Access Compliance Report

Public Rights-of-Way

(Curb Ramps)

Intersection ID: 16483	Main Street: QUEENS_RD	Cross Street: RADCLIFFE_AV	Location: NW
ADA ID: BFA0B51AD1B6	Ramp Type: PerpDiag	Initial Pass/Fail: Fail	Overall Compliance: No
Severity Score: 12.5			
Codes/Mitigation Info/Possible Solution		Field Measurements/Component Compliance

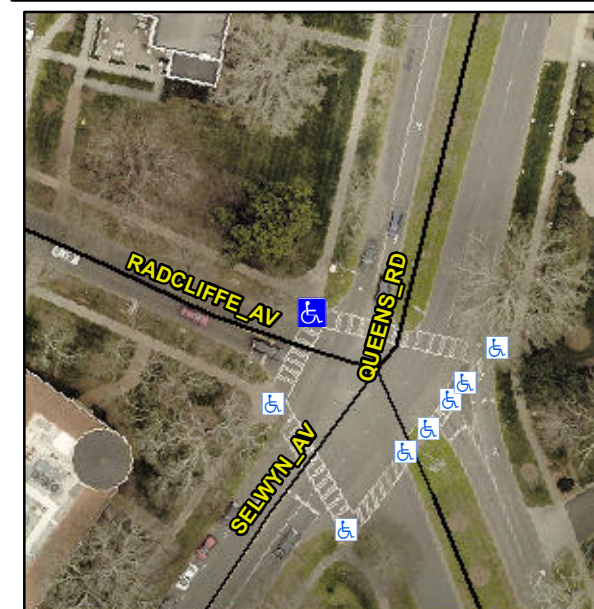
Not Found, R304.2.2

Compliance	Description	Data	Compliance	Description	Data
N/A	Ramp Length (in)	82.5	No	Ramp Slope (%)	8.6
Yes	Ramp Width (in)	50.5	Yes	Ramp XSlope (%)	0.0
N/A	Flare Type LT	N/A	N/A	Flare Type RT	N/A
N/A	Flare Slope LT (%)	N/A	N/A	Flare Slope RT (%)	N/A
N/A	Flare Traversable LT?	N/A	N/A	Flare Traversable RT?	N/A
N/A	Landing Length (in)	N/A	N/A	DWS Provided?	N/A
N/A	Landing Width (in)	N/A	N/A	DWS Contrast?	N/A
N/A	Landing Slope (%)	N/A	N/A	DWS Length (in)	N/A
N/A	Landing X Slope (%)	N/A	N/A	DWS Full Width?	N/A
N/A	Landing Curb? (Y/N)	N/A	N/A	DWS Offset (in)	N/A
N/A	Shared Landing?	N/A			
N/A	Gutter Ponding?	N/A	N/A	Gutter Slope (%)	N/A
N/A	Gutter Lip Ht (in)	N/A	N/A	Gutter X Slope (%)	N/A
N/A	Painted X Walk1?	Yes	N/A	Painted X Walk2?	Yes
	X Walk 1 Direction	To SW		X Walk 2 Direction	To SE
N/A	X Walk 1 Width (in)	112.0	N/A	X Walk 2 Width (in)	106.0
	X Walk 1 Slope (%)	3.0		X Walk 2 Slope (%)	4.6
	X Walk 1 X Slope (%)	2.8		X Walk 2 X Slope (%)	0.1

Remove & Replace Curb Ramp With Two New Directional Ramps or Equivalent.
